# independent assessment of s.96(2) application

To Modify Consent No. 198/2015  
For Staged Redevelopment of Rosenthal Car Park

Various Lots  
Nos. 2-20 Rosenthal Avenue,  
Lane Cove

# REPORT TO JRPP – S.96 DA 198/2015 2 – 20 ROSENTHAL AVENUE, LANE COVE

Figure 2 (Source: Scott Carver)

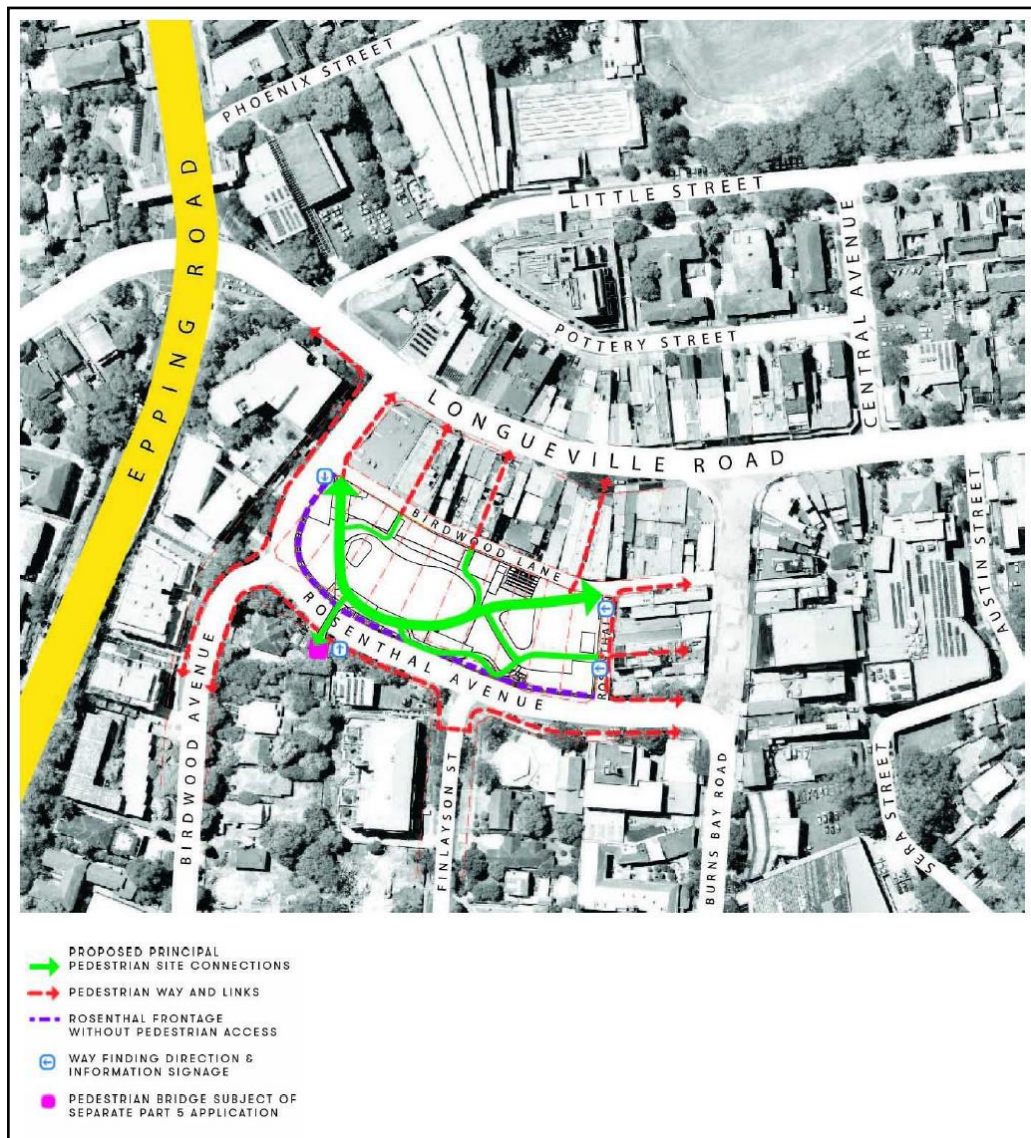
The applicant seeks to delete this condition for the following reason:

*Footpath access along the Rosenthal Avenue frontage is not considered appropriate having regard for pedestrian safety nor considered necessary due to the alignment of the levels of Birdwood Lane and the public open space. Alternative pedestrian access through the public open space and linking to the proposed pedestrian bridge (subject to separate Part 5 approval) is proposed.*

Condition 12 of the Stage 1 Consent requires suitable pedestrian access to be provided along the full length of the Rosenthal Avenue frontage. Following pre-lodgement discussions with Council, it is understood that this condition was included in the Stage 1 Consent in response to an issue raised by an objector during the SEJRPP hearing. In particular, the footpath at road level along Rosenthal Avenue had been removed as part of the Stage 1 concept given the location of the loading dock and car park entry. Therefore, pedestrians could not continue on-grade along the Rosenthal Avenue frontage and were required to either use stairs to access the public open space or cross over Rosenthal Avenue.

This issue has been resolved as part of the proposed development by aligning the level of the public open space with Birdwood Lane thereby allowing pedestrians to continue walking on-grade with a clear line of sight to the pedestrian bridge. Pedestrians can then utilise the bridge (subject to separate Part 5 approval) to cross Rosenthal Avenue, or continue through the park to the corner of Rosenthal Lane and Rosenthal Avenue. The proposed pedestrian connections are considered to present a safer option than an elevated footpath around the perimeter of the site. The principal site connections are detailed in Figure 2.

Condition 12 is to be amended to read:

*“A pedestrian bridge shall be constructed across Rosenthal Avenue generally in the location indicated on the approved plans. Approval of an application under the Roads Act is to be obtained for the bridge prior to its construction. The bridge is to be completed to the satisfaction of Council and the Roads Authority prior to the issue of the occupation certificate for the development.”*
